PLAN COMMISSION/HISTORIC PRESERVATION COMMISSION
WEDNESDAY, APRIL 27, 2016

Mike Slavney's April 26, 2016 comments regarding 108 S Second Street project:

FIRST FLOOR PLAN

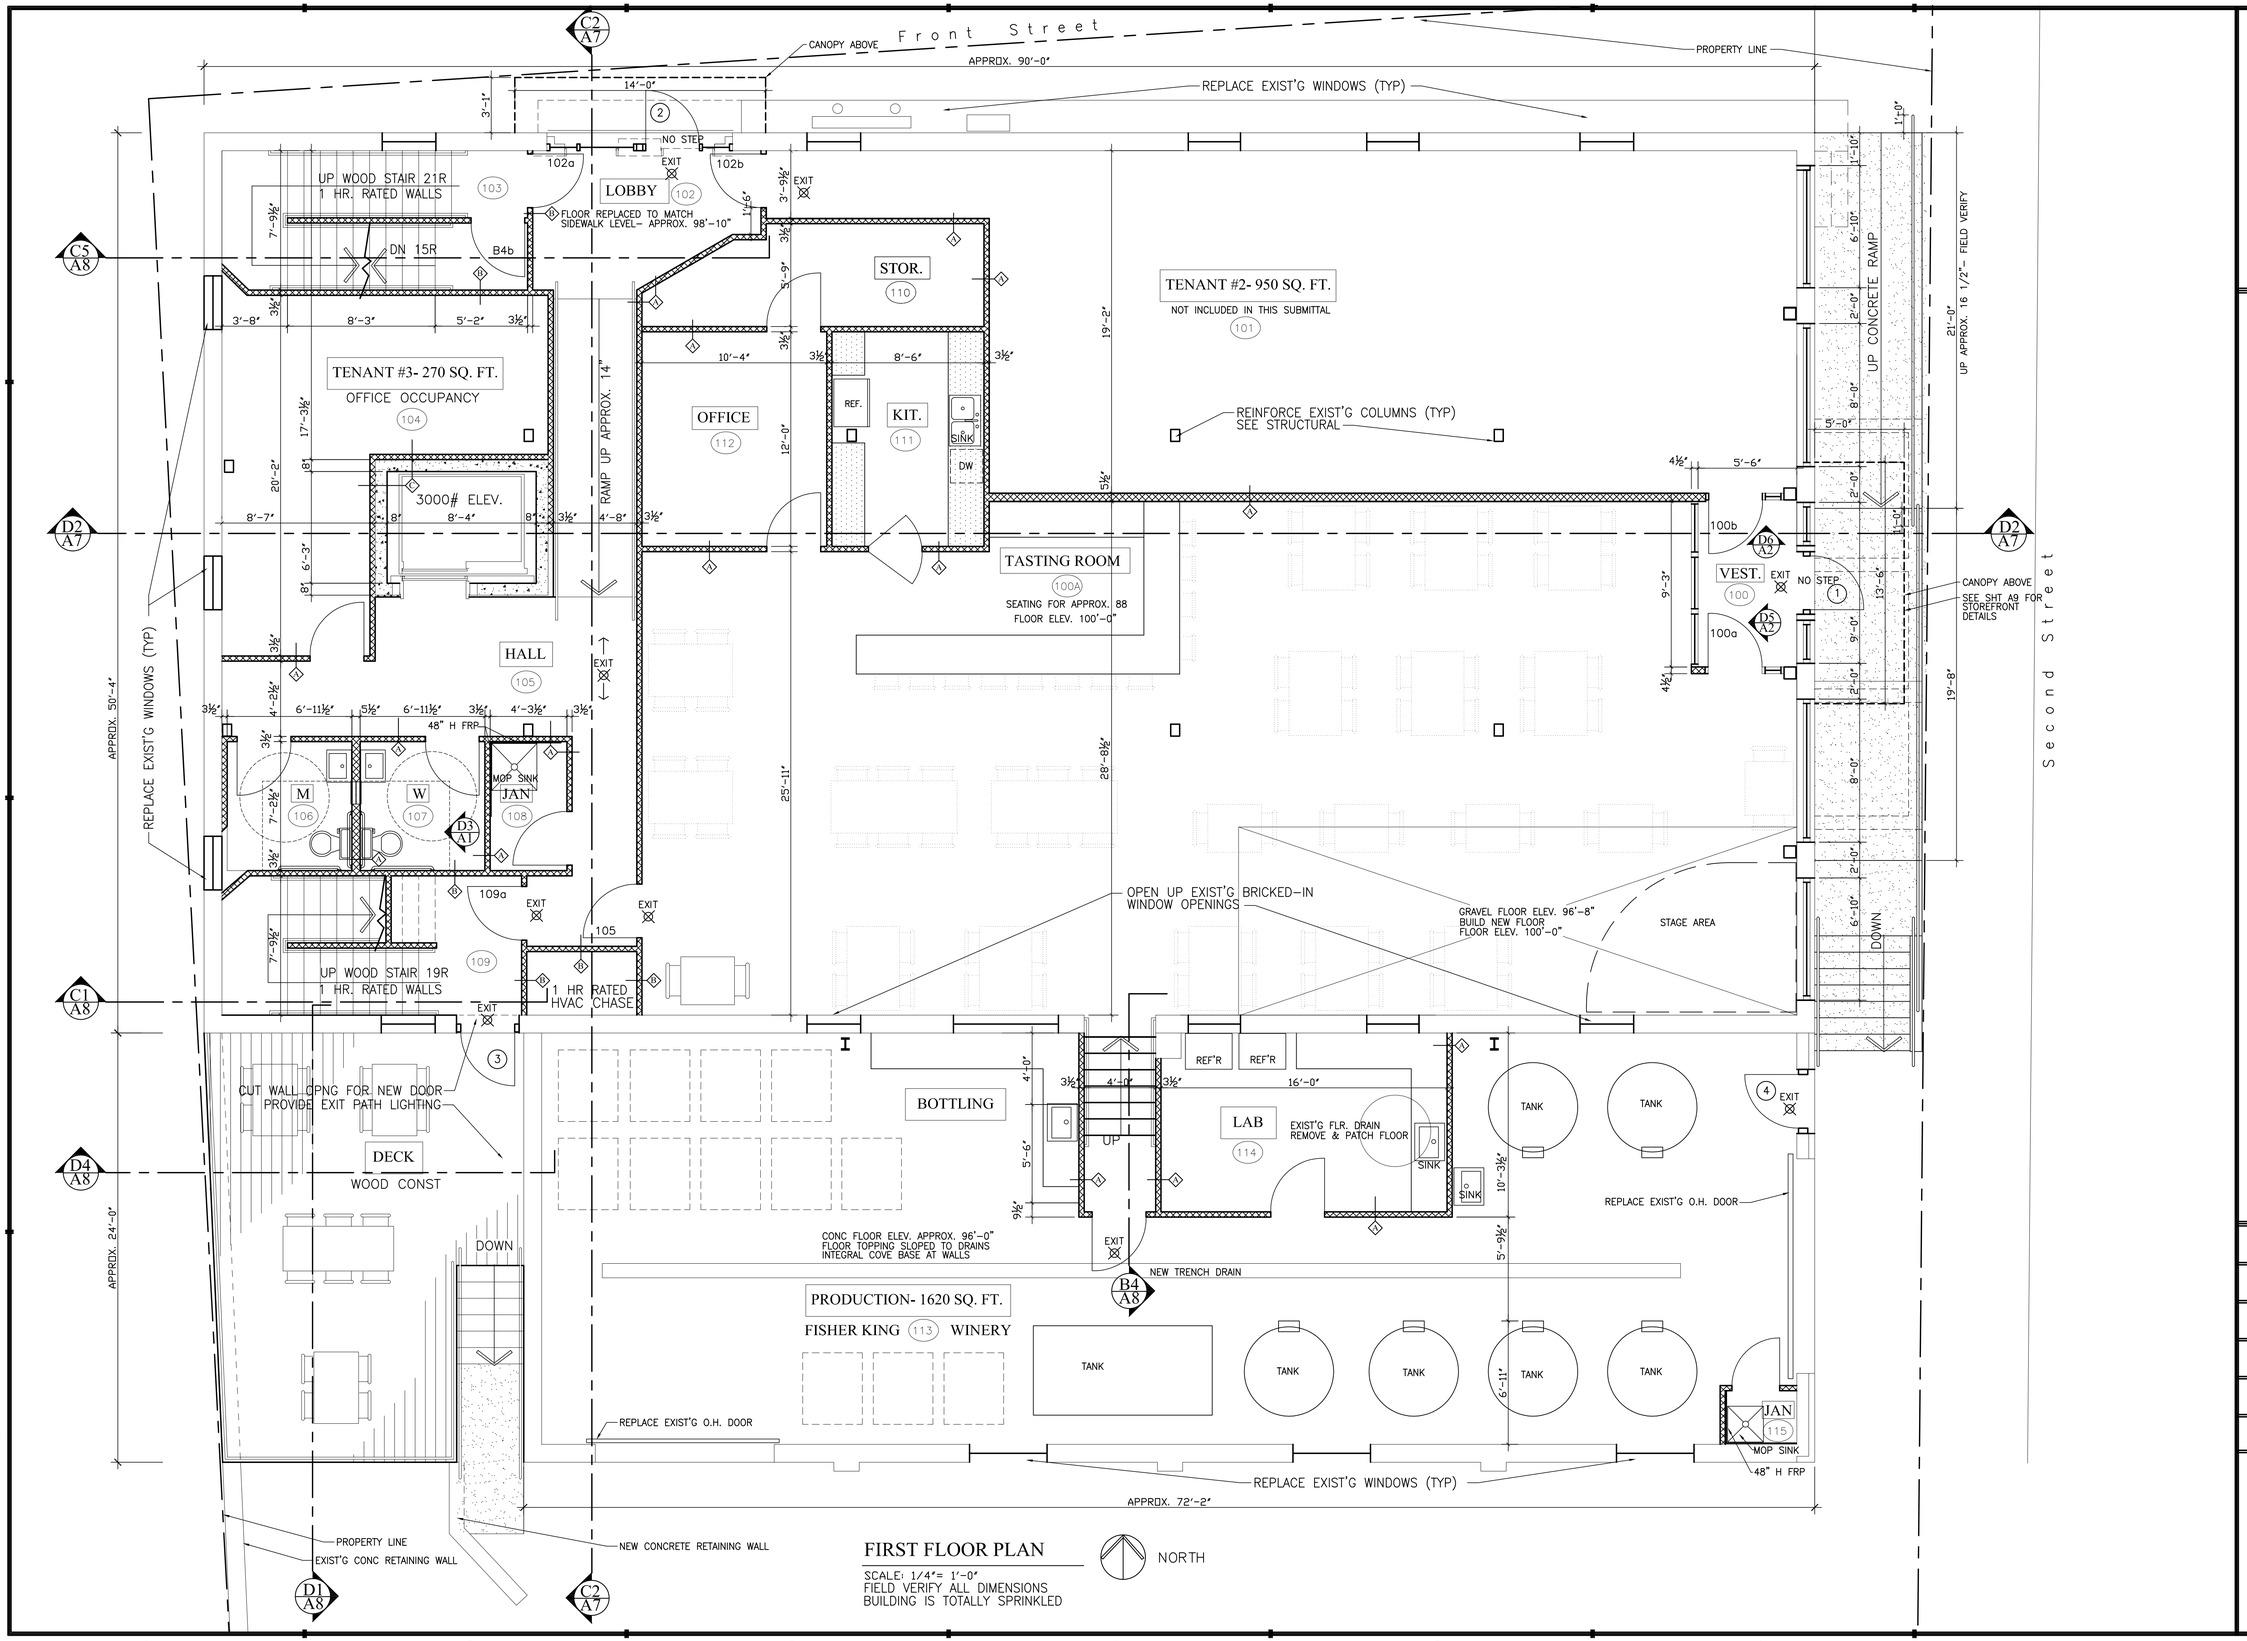
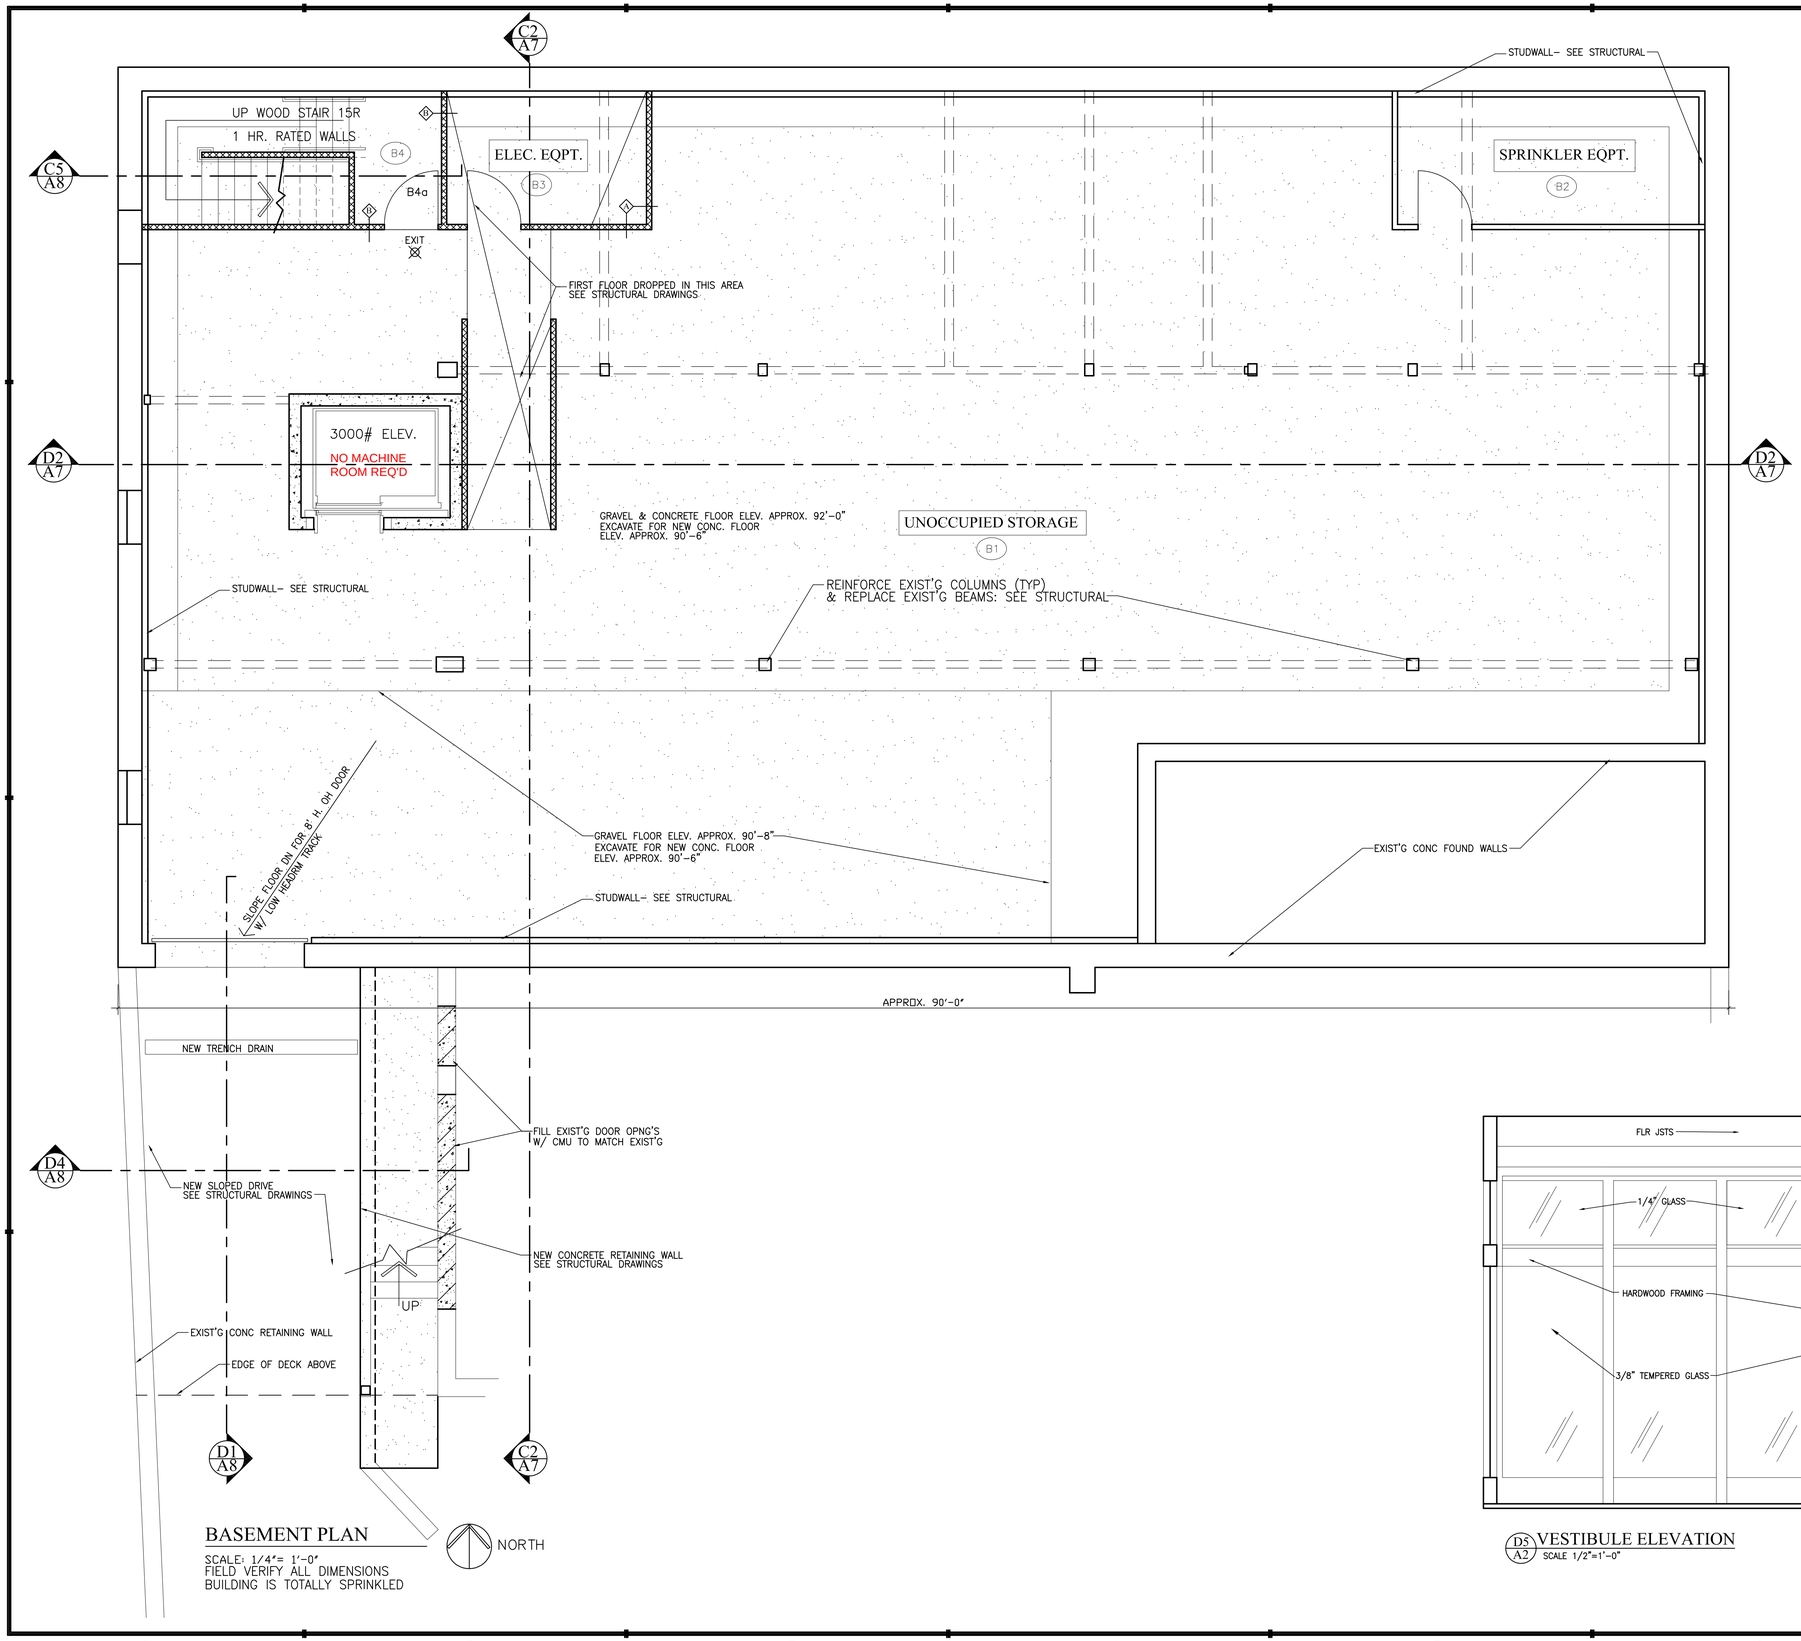
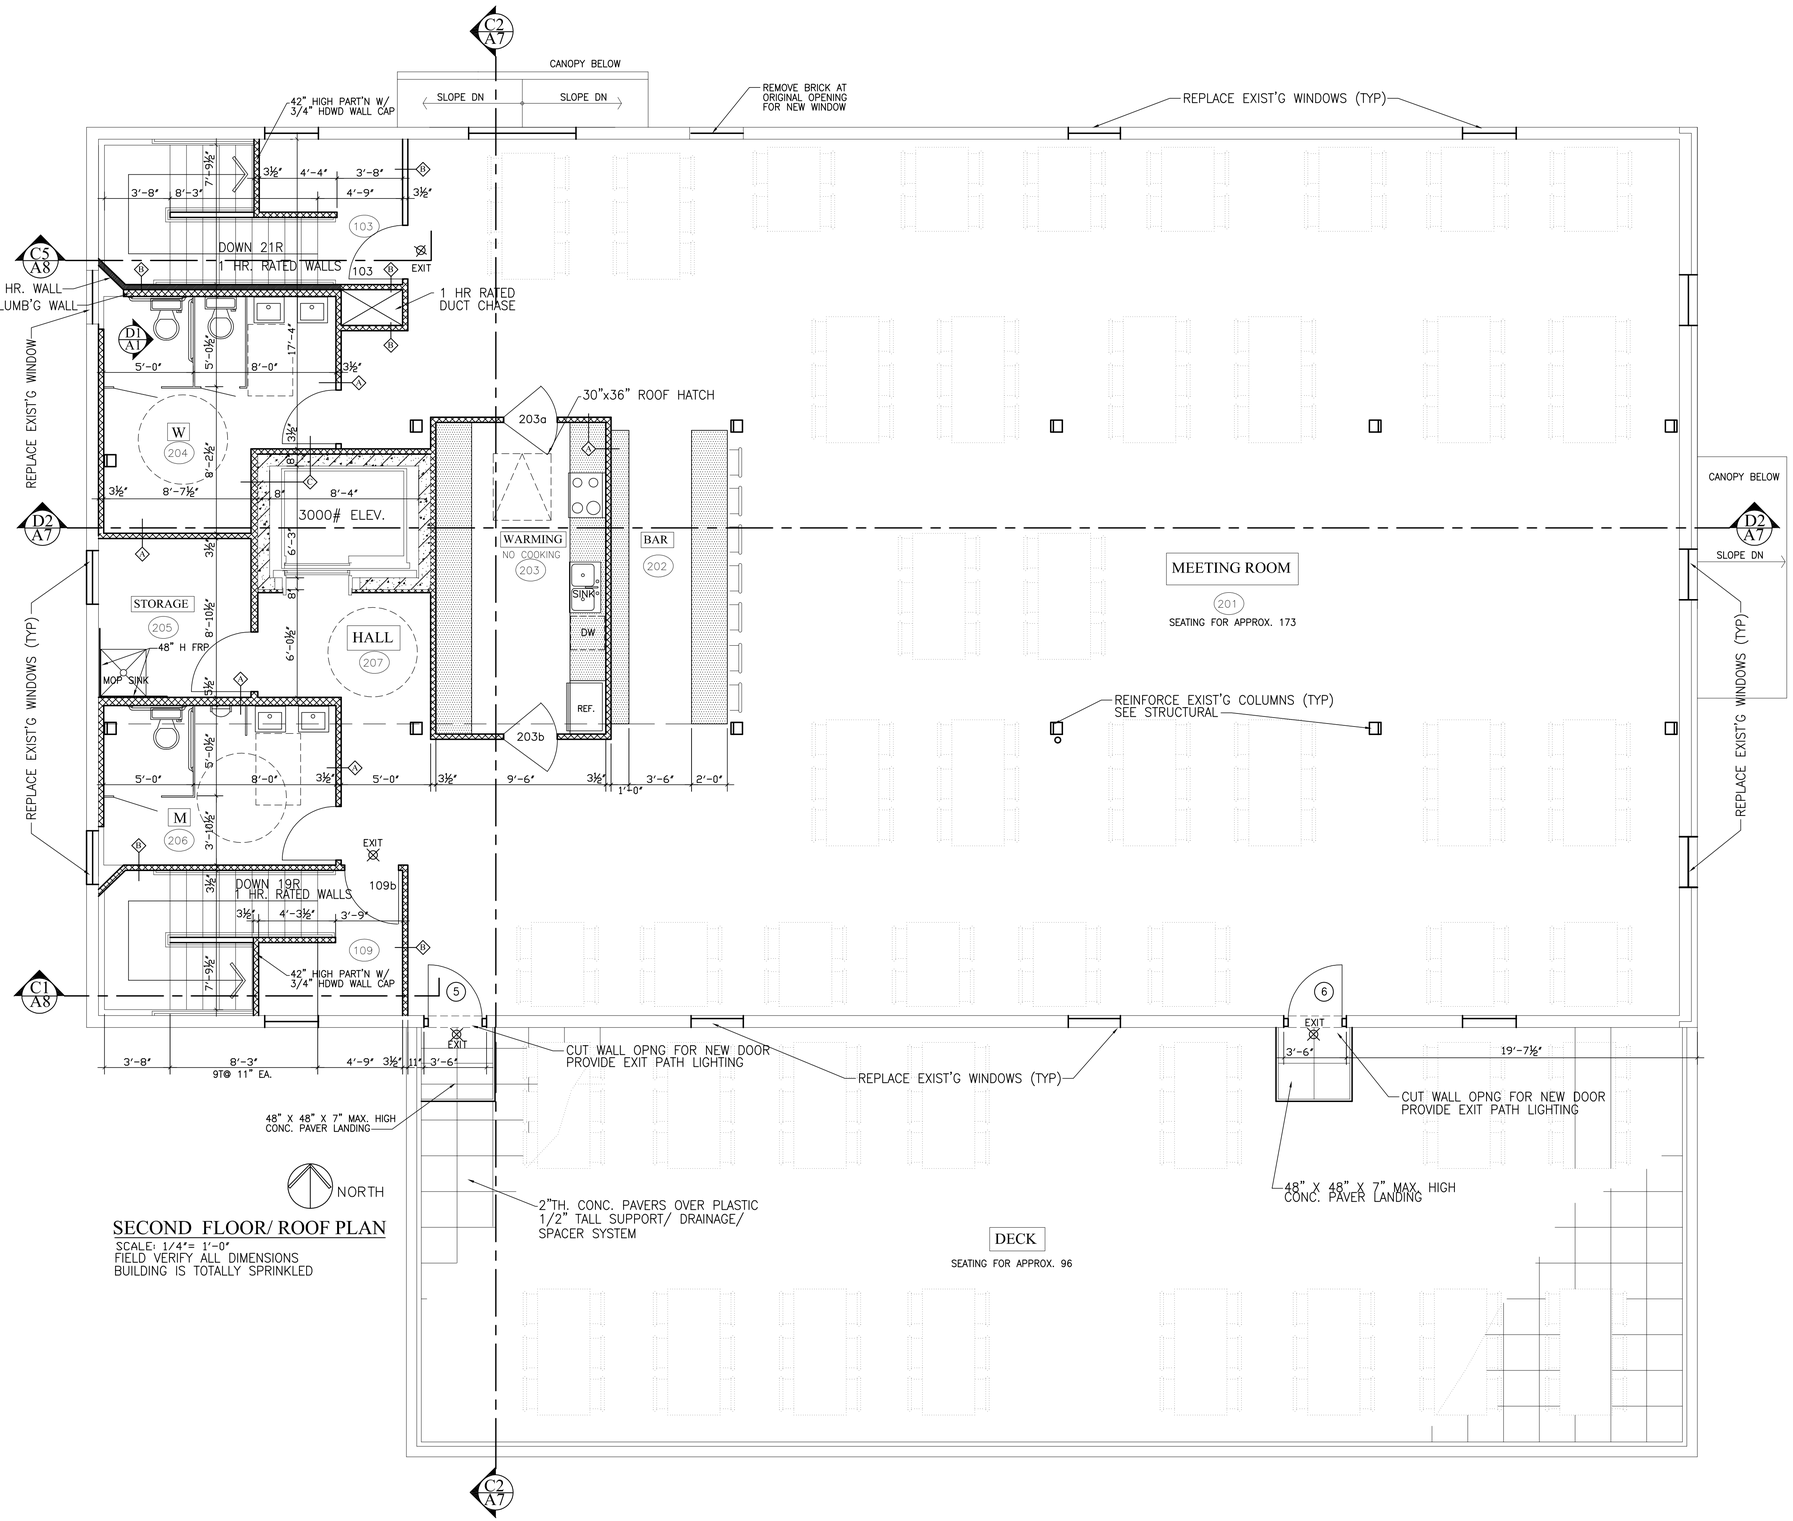
My only suggestion is that the conditional use permit clearly identify:

1. the locations for indoor and outdoor commercial entertainment;
2. the maximum permitted hours of operation of each entertainment space; and,
3. limitations on amplified and non-amplified music – if any are needed in this location

For 1) Labels could be placed on the floor plans for entertainment areas, and a short paragraph could clearly list the floor plan areas for indoor or outdoor entertainment

For 2) The short paragraph listing the areas, in 1), above, could also list the maximum hours.

- 6 am to bar time sounds OK to me for all indoor areas
- 7 am to midnight sounds OK to me for all outdoor areas

For 3) Typically, projects don't put limits on indoor entertainment. Typically, there are limits on outdoor entertainment areas.

- No amplification or live music after 10 pm or before 8 am outdoors Sunday through Wednesday
- No amplification or live music after 12 am or before 8 am outdoors Thursday through Saturday
